MEETING OF TOWN OF VERONA PLAN COMMISSION

Thursday February 15, 2024, 6:30 p.m.

3. Approval of Minutes from January 18th, 2024
4. Discussion and Possible Action: Land Use Application 2023-01 Sugar River Road Properties Concept Plan Review and Rezone

- a. Staff report
 - b. Applicant comments
 - c. Public comment
5. Discussion and Possible Action: Land Use Application 2024-02 Riverside Vista (062/0608-303-9000-8 east of 7906 Riverside Road) Preliminary Plat, Declaration of Covenants and Developer's Agreement

YOUR NATURAL RESOURCE FOR LAND DEVELOPMENT

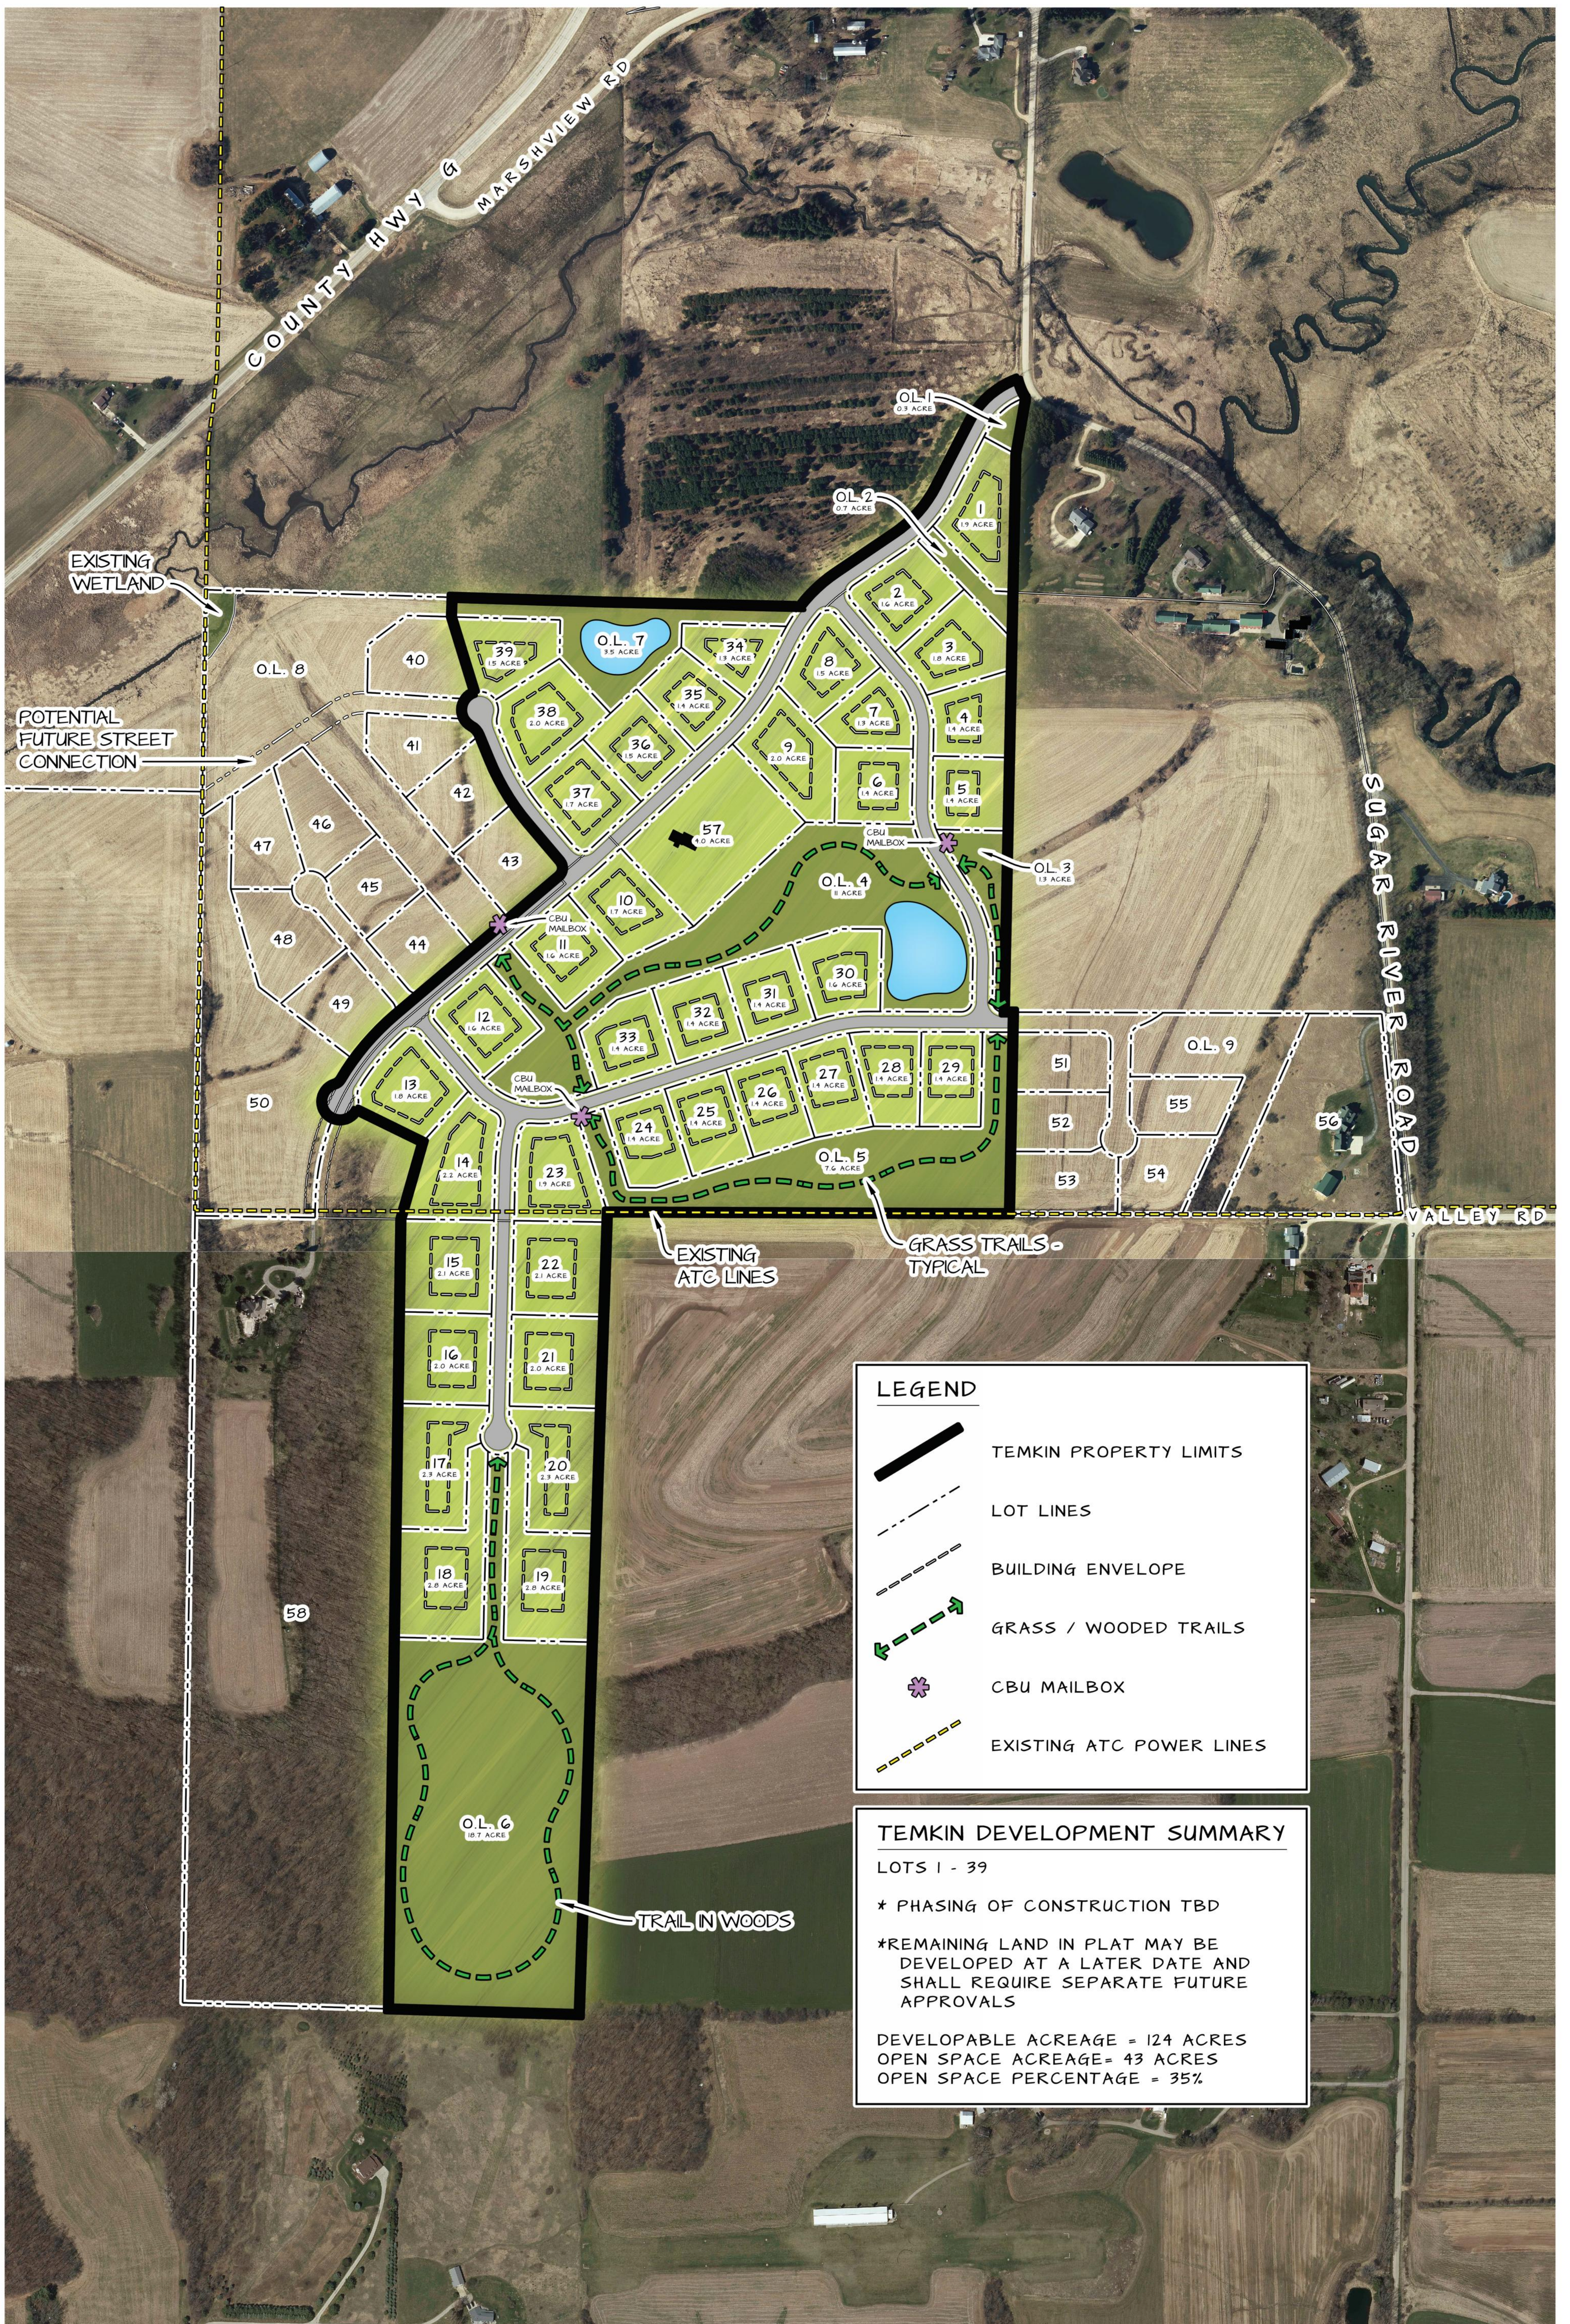
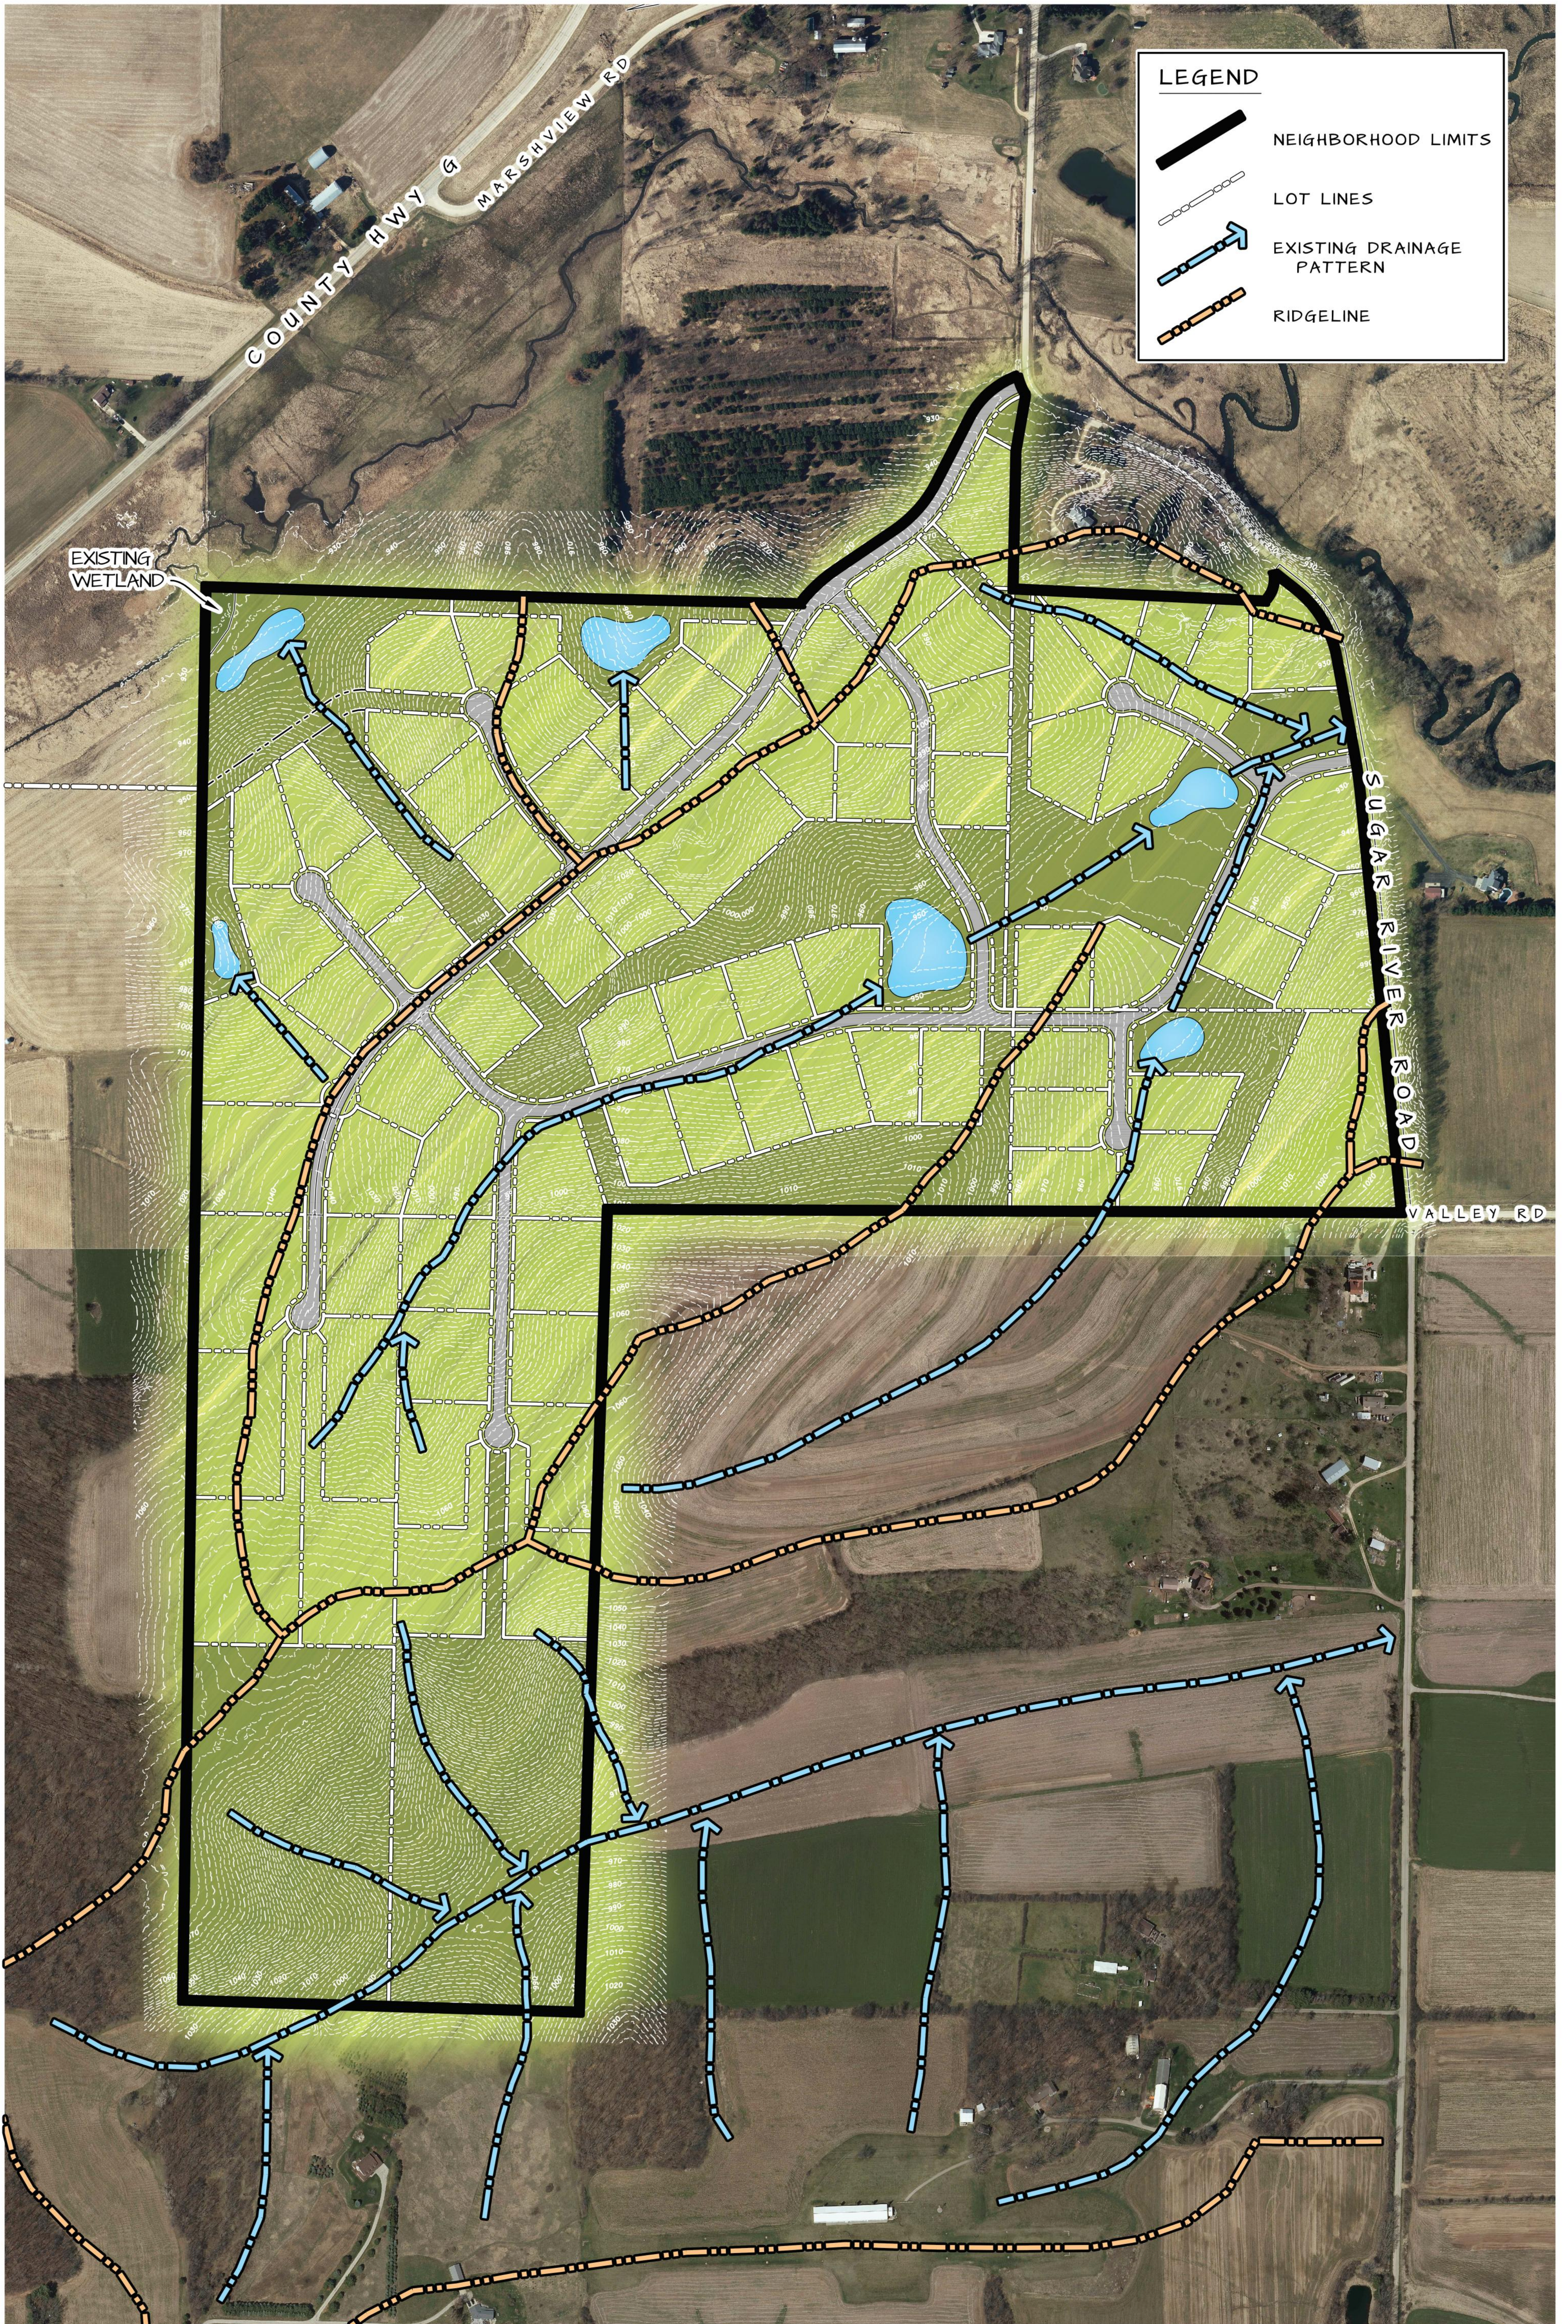
- Design speed of roads is preferred to be 25mph
- County documentation of manure management plan would be helpful
- Lots 19-22 may need to be shifted to accommodate 300' distance for well placement

- Phasing of road construction
- Mailbox locations should be examined to minimize inconvenience to current residents (location likely dictated by USPS)
- Better explanation of the methods employed in the Traffic Impact Analysis

- Application needs to include vision triangle, floodplain, slopes between 12 and 20%, existing wells and septic fields on the existing conditions map
- Generally supportive of the design
- Design changes made to date are favorable and reflective of the Comprehensive Plan
